# EIGHTEEN SUNSET

1733-1759 PURDY AVENUE & 1724-1752 BAY ROAD  
MIAMI BEACH, FLORIDA

DESIGN REVIEW BOARD FINAL SUBMITTAL FILE NUMBER DRB22-0814

APRIL 11, 2022

**SITE PLAN**

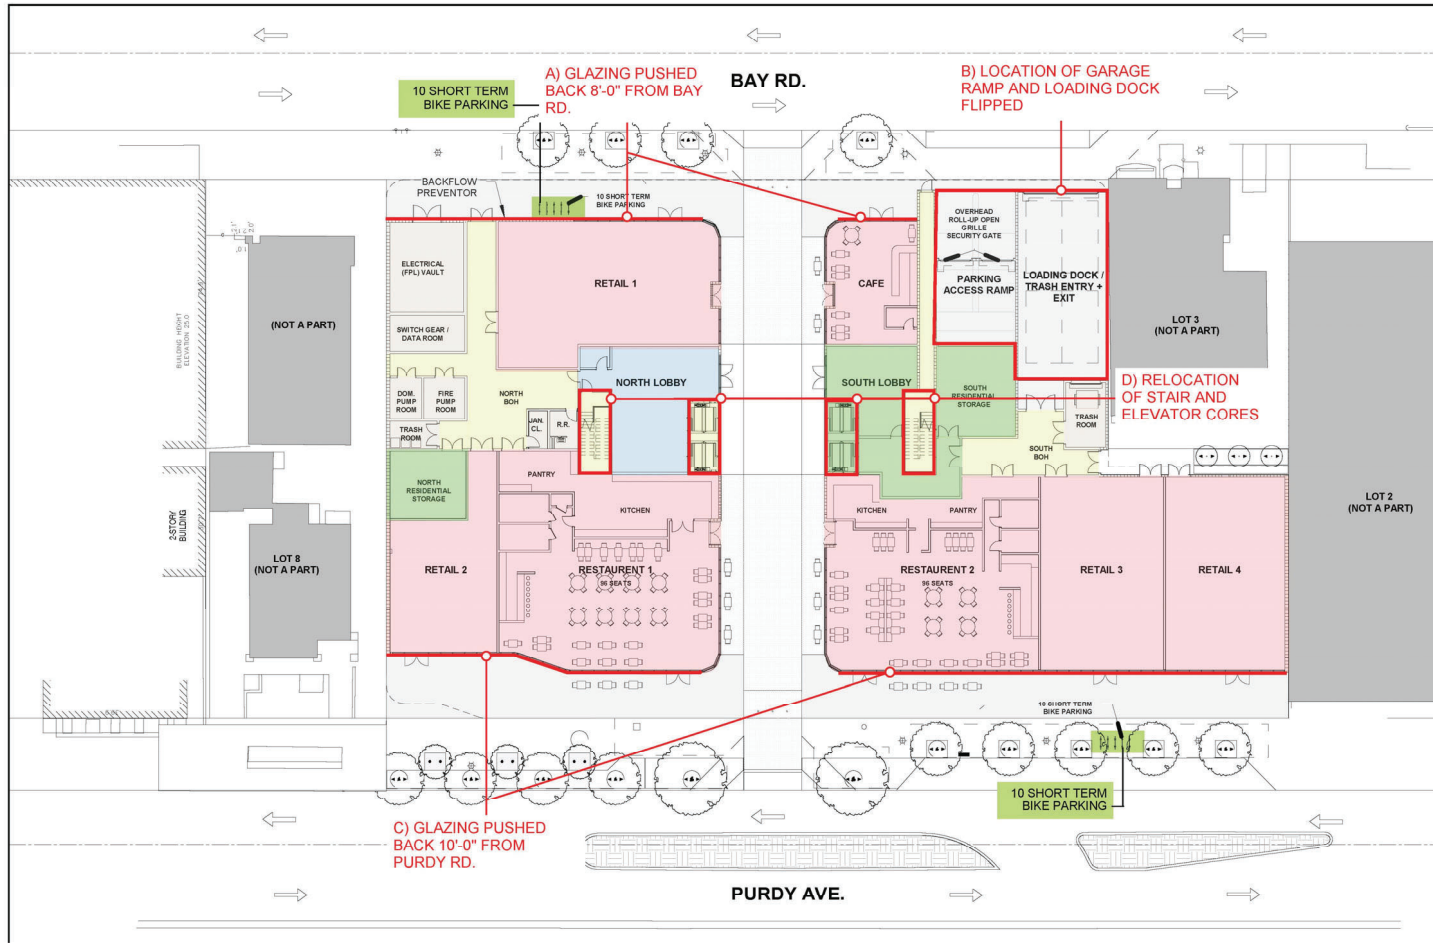
- A) GLAZING PUSHED BACK 8'-0" FROM BAY RD.
- B) LOCATION OF GARAGE RAMP AND LOADING DOCK FLIPPED.
- C) GLAZING PUSHED BACK 10'-0" FROM PURDY RD.
- D) RELOCATION OF STAIR AND ELEVATOR CORES.
- F) ROOF POOL RELOCATED.
